From: [GreenRebstock, Jan](#)
To: [Chad Beckstrom; Rachel Struglia;](#)
Subject: FW: Waterfront DEIR - DCP comments
Date: Tuesday, December 09, 2008 9:54:04 AM
Attachments: [Pola DEIR DCP comments 12.8.08.pdf](#)

Re: DEIS/DEIR for the San Pedro Waterfront Project (ADP#041122-208)

Clarifications/Comments

Figure 1 Project Components within the San Pedro Community Plan Area

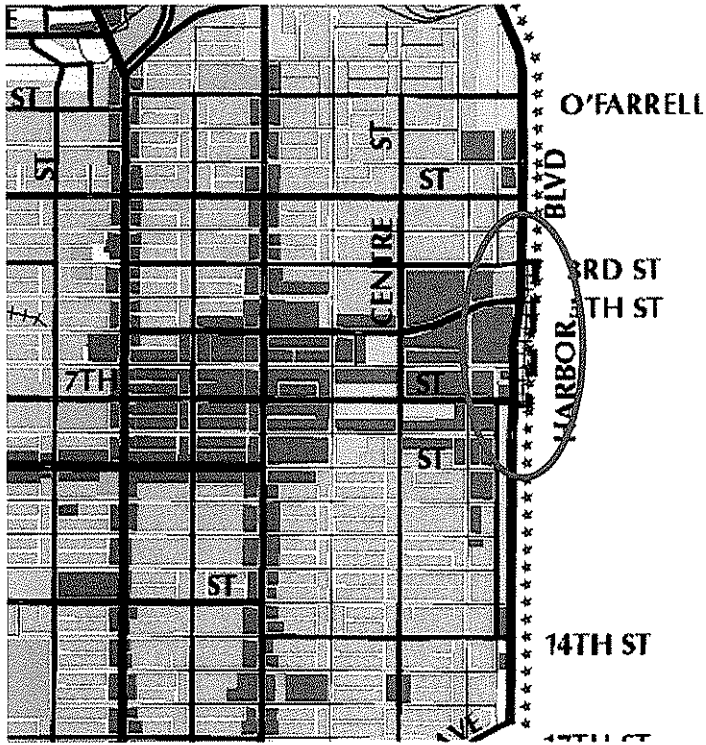
4. **Land Use and Planning:** Page 3.8-1, lines 18-21, states “the entire project site is contained within the Port of Los Angeles Plan area”. (Page 7-70 lines 30-34 and Page 7-31 lines 7-11 similarly mischaracterize the project area.) As reflected in both the San Pedro Community Plan Land Use map and the Port of Los Angeles Plan map a more accurate description would state that the project includes components that are located within the San Pedro Community Plan area: the west side of Harbor Boulevard from Swinford to 22nd Street; and along both sides of Harbor Boulevard between 3rd and 7th Streets (see Figure 1 attached). This area in particular is designated Open Space and Light Manufacturing and zoned OS-1 and [Q]M-2. Project improvements may require plan amendments or zone changes for the San Pedro Community Plan area.

- a. Additionally mitigation measures (TC-6-9, 12, 13) are proposed along Gaffey, Miner, and 22nd Streets, which are all wholly within the San Pedro Community Plan. All mitigation measures affecting Harbor, Gaffey, Miner and 22nd Streets need to be consistent with Community plan street designations and/or require amendments. Such changes must be coordinated with DCP and LADOT.

- b. The project description should include figures depicting the San Pedro Community Plan land use designations and zoning categories.
5. Impact LU-3, lines 18-23 on Page 3.8-27, the discussion of impacts describes the project as resulting in “less impact to the community than was originally planned”, this statement may be confusing as to what is being analyzed; this section could be revised to discuss the current project only. It further describes that Harbor Boulevard will be maintained as 2 lanes in each direction. However the mitigation measures to minimize the impact of this project component reconfigures Harbor Boulevard to 3 lanes from Swinford Avenue to 5th Street. The statement of impact is unclear. Physical connectivity between the waterfront and the community is of vital importance. If Harbor Boulevard is ultimately to be 3 lanes in each direction, design must deter high speeds and ensure pedestrian safety. Mitigation measures should be included in the EIR/EIS to address design, aesthetics, and pedestrian and bicycle safety.
